Investigation and Considerations about Option #2
(install SuperFGD in ND280 w/o HA-TPC's:
Install SFGD in ND280 – uninstall it – install Bottom
TPC – install SFGD in ND280 again)

Option #2: considerations from WG1

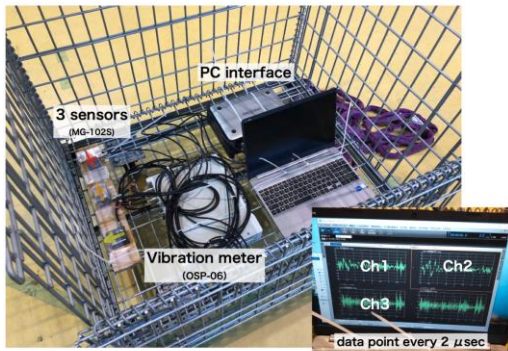
Comments from Franck

- To be considered the cabling/uncabling work
 - not a big issue for SFGD (C.Mauger - Electronics WG)
 - more complicated for ToF detector because it's more fragile and has a lot of cables to be plugged (F.Cadoux)
- It may be considered to install SFGD w/ partial ToF installation, i.e. that does not need to be removed later for Bottom-TPC installation
- Be careful to avoid shocks - Typical risk during detector installation

Summary: Risk assessment of the crane acceleration in the lifting

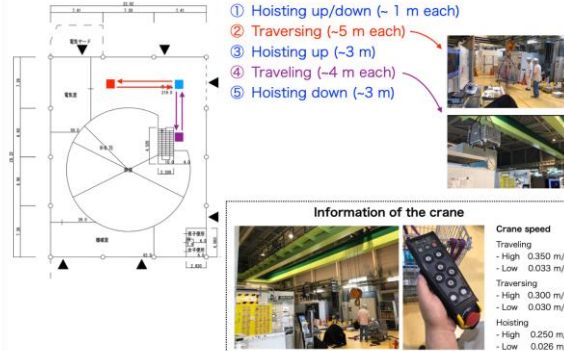
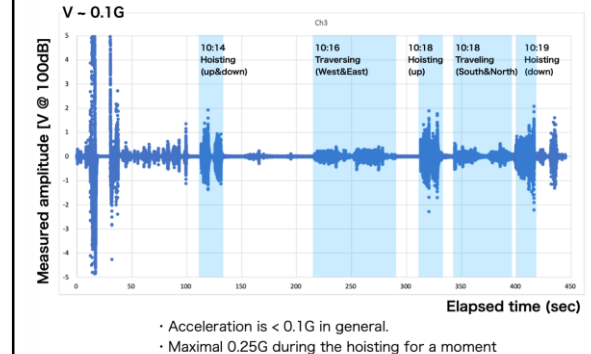
- Acceleration measurement of the crane at the NM building were performed to evaluate the risk in the lifting detector.

- Comparable with the general standard value of 0.1G in every direction.
- Lower acceleration than the seismic standard of 0.65G is confirmed.
→ Relatively small risk w.r.t. the requirement for an earthquake.
- Other risk mitigations under discussion
 - A guide to the basket during the detector installation
 - Transportation between buildings (NA → NM)

Figure 6-59 Scenario 1 – Vibration in Z direction – Results at the Bottom Panel

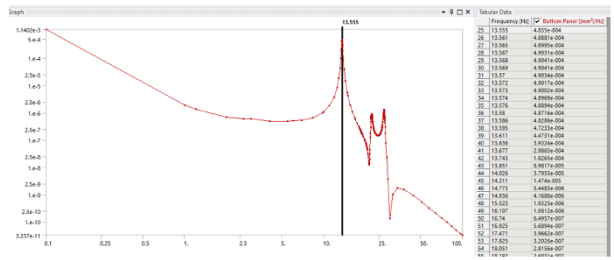
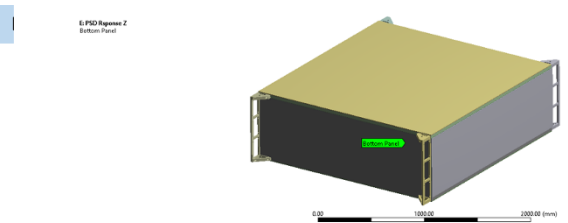
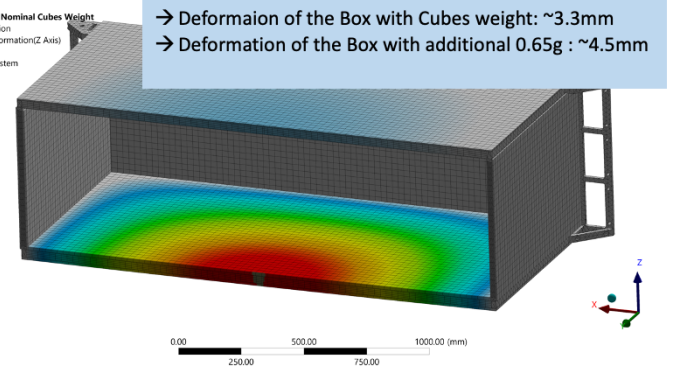
- Deformations at the Box caused by using crane are negligible.
- Vibrations induced from the crane are for sure not worse than vibrations caused by an earthquake

A peak is found at 13,555 [Hz] with a PSD of 4.855e⁻⁴ [(mm²)/Hz]

Indicatively vibrational amplitude derived of the Bottom Panel → A=0.081 mm

E: S
Total Deformation
Type: Total Deformation
Unit: mm
Time: 1
Max: 3.3063
Min: 0

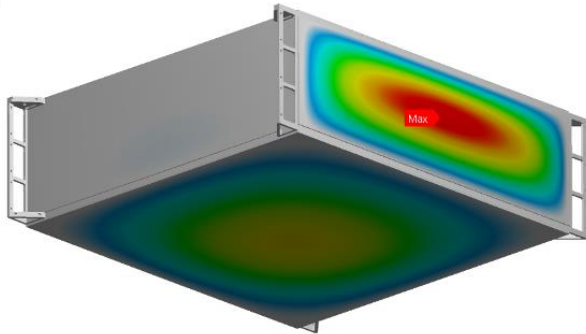
Static FEA analysis (worst-case scenario): all cubes move together along the same direction. Very unlikely

- Max deformation ~2.6mm bottom panel, smooth
- 1.65G along Z (gravity + earthquake)

- Max deformation ~4.3mm bottom panel, smooth

Still 1G along Z (gravity) and 0.65G along Y

- No change on bottom panel deformation.
- Max ~3mm side panel deformation but smooth
- Near the box holes the deformation is almost 0

Important consideration: the FEA static shows the worst-case scenario to be considered as a safety margin that the target (5mm max deformation) is achieved

Stress at the Bracket during Lifting

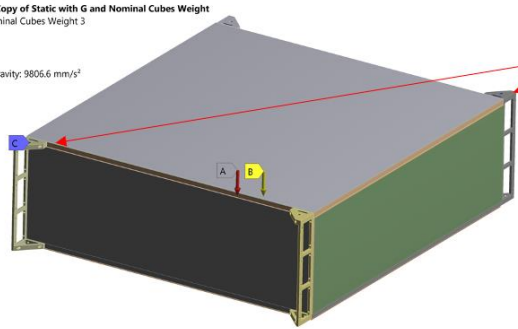
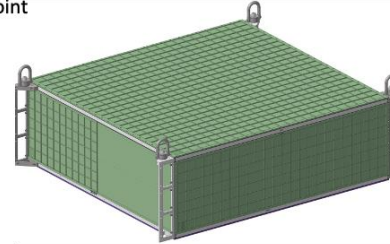
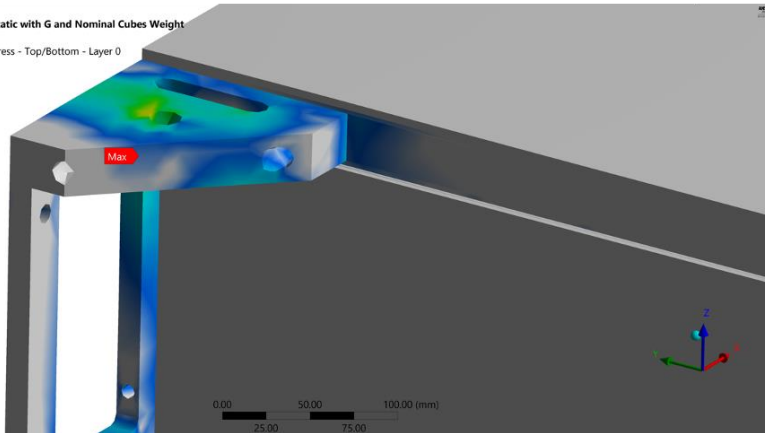
- Force 37'224 N → Cubes weight + 0.65g
- Only 2 Anchoring Point

Max Stress at the Bracket:
152Mpa

MoS= 0.577

The static FEA were done by applying the acceleration also to the side panels of 0.65G. Irrelevant the impact of the slightly different boundary conditions between lifting and basket (e.g. 2 vs 8 anchoring points), also given the fact that the static FEA is the very worst-case scenario, very unlikely to happen
